August 7, 2023
AVO 37449

Re: Dollar General Final Plat and Construction Plans
First Review

The City of Sanger requested Halff Associates, Inc. review the Dollar General Final Plat and Construction Plans prepared by Triangle Engineering LLC. dated June 21, 2023. We have completed our review and have the following comments:

PAVING PLAN
DOLLAR GENERAL
NE QUADRANT OF FM 2450 & CHAPMAN ROAD
CITY OF SANGER ETJ
DENTON COUNTY, TEXAS 76266
JAMES B.P. JANUARY SURVEY ABSTRACT NO # 658

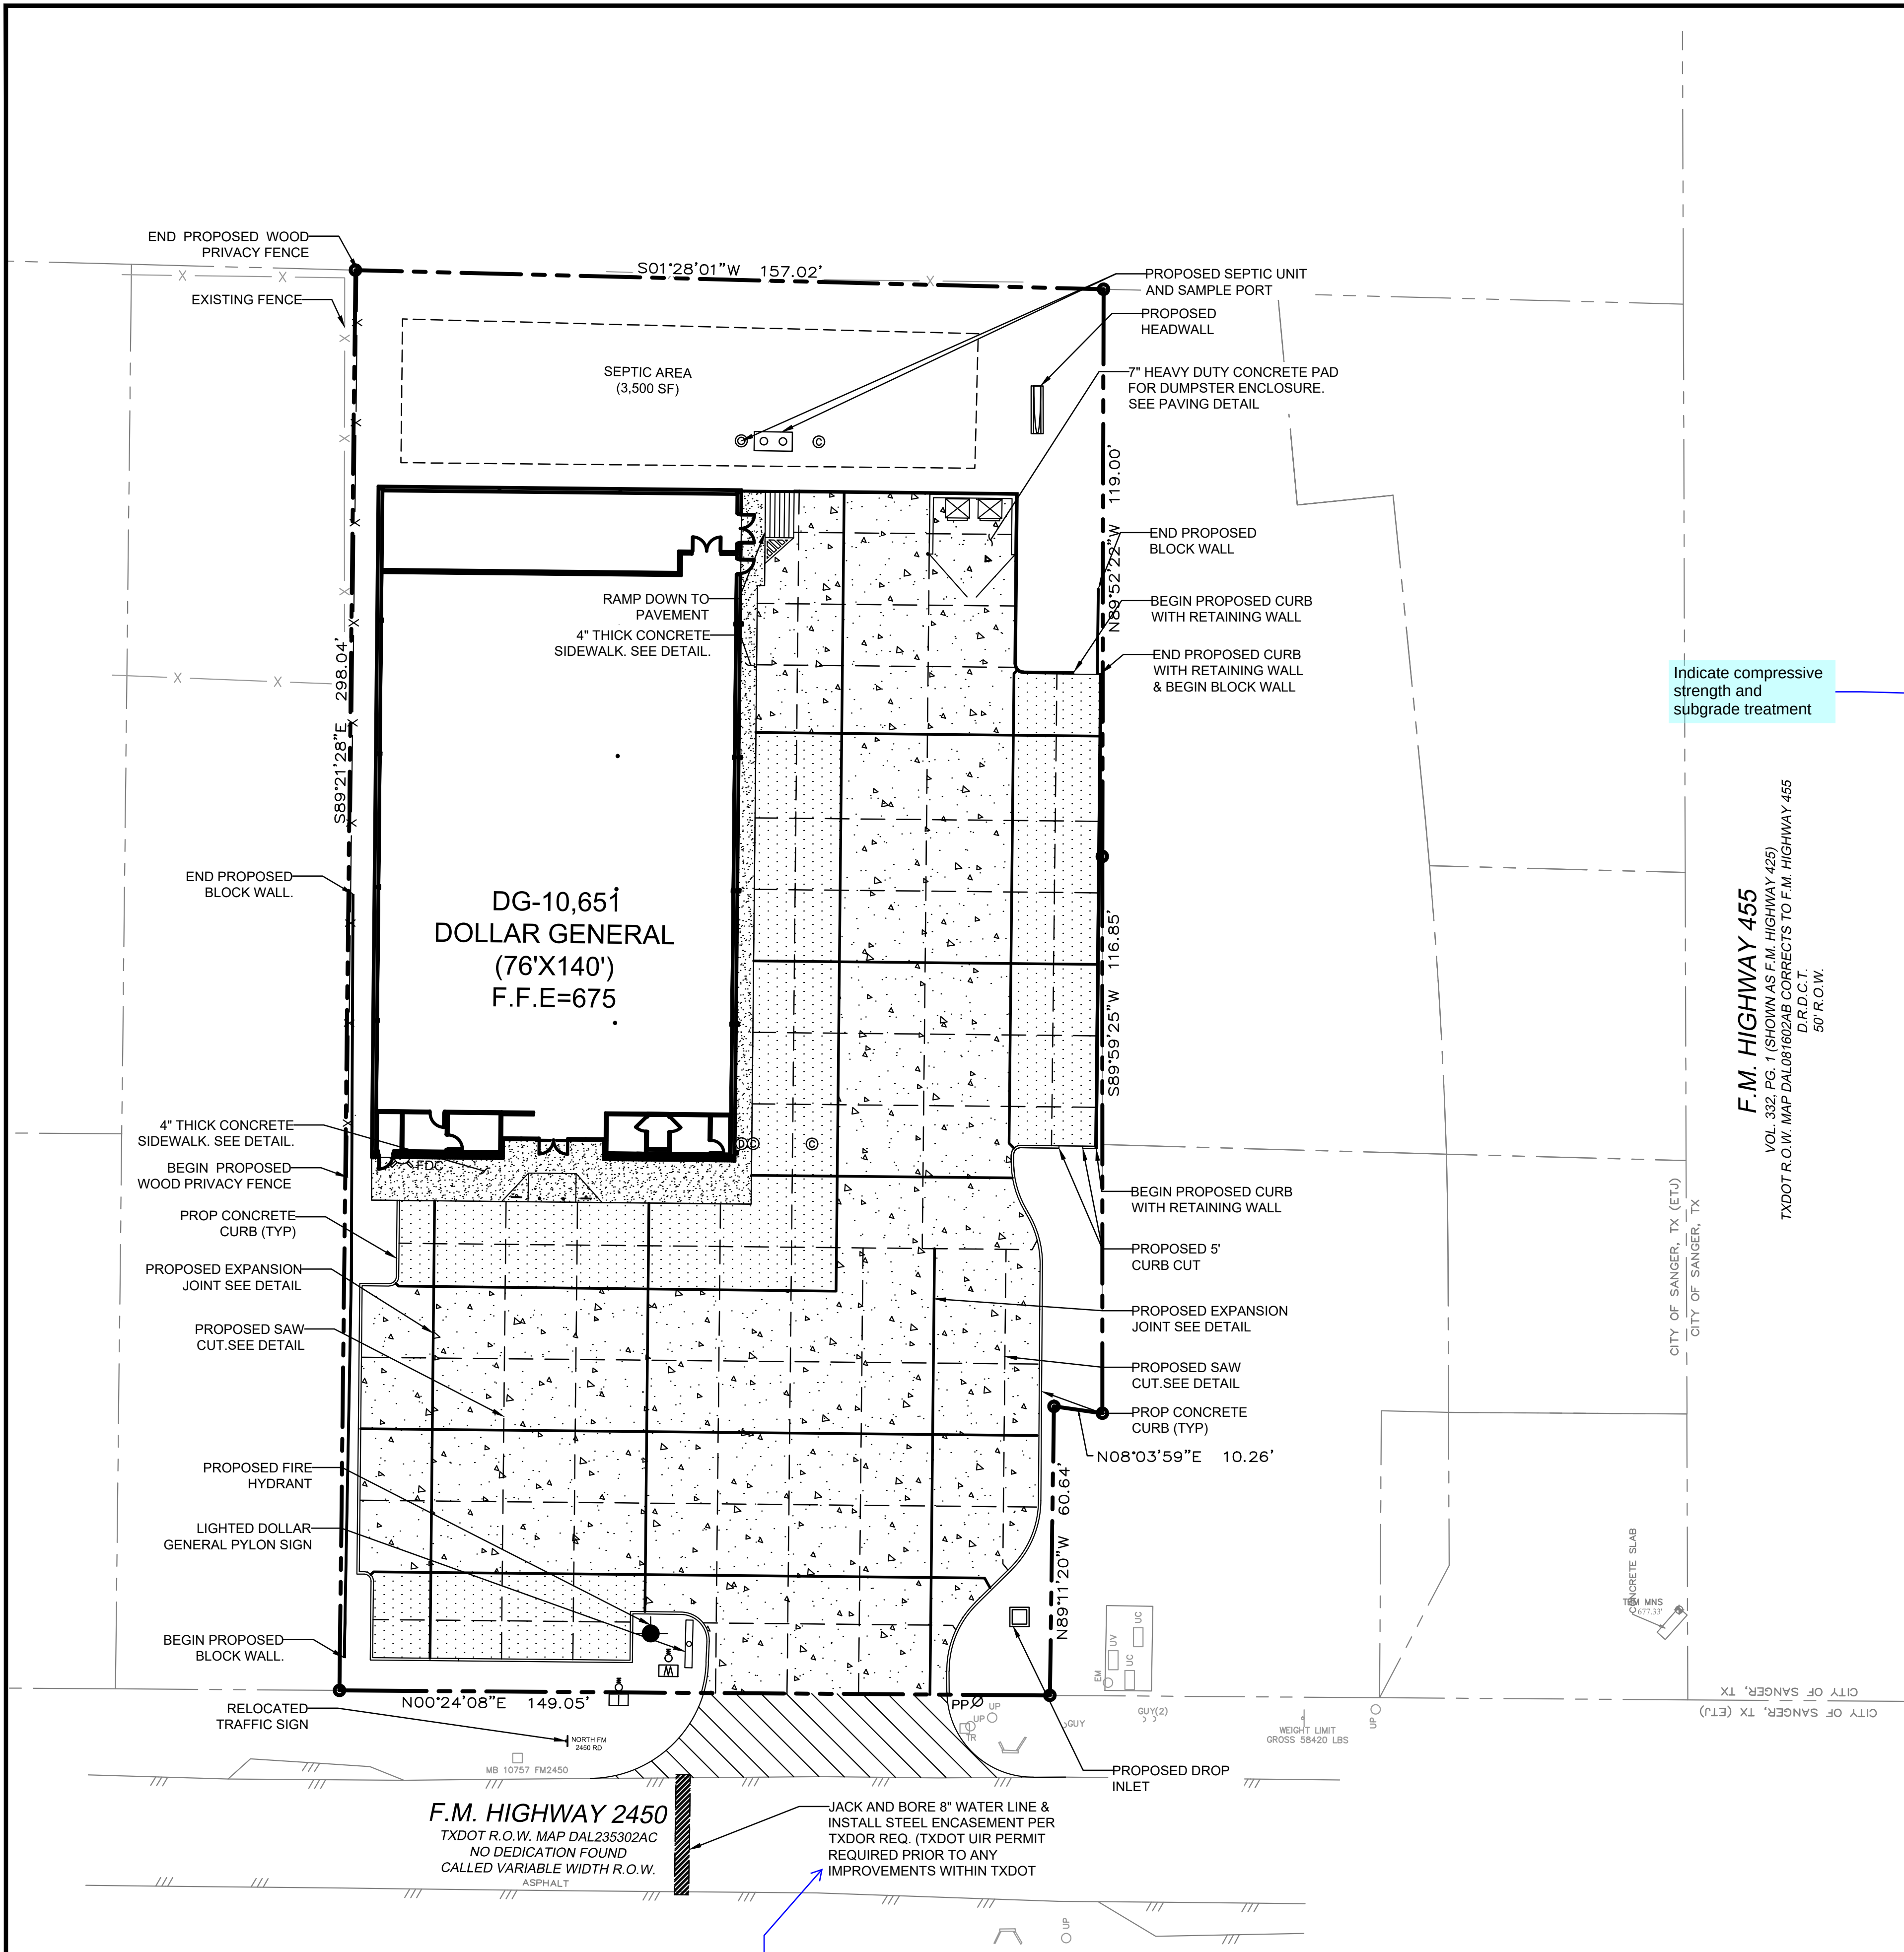
15. Provide paving compressive strength requirements and subgrade treatment.

Provide plans for TxDOT permit
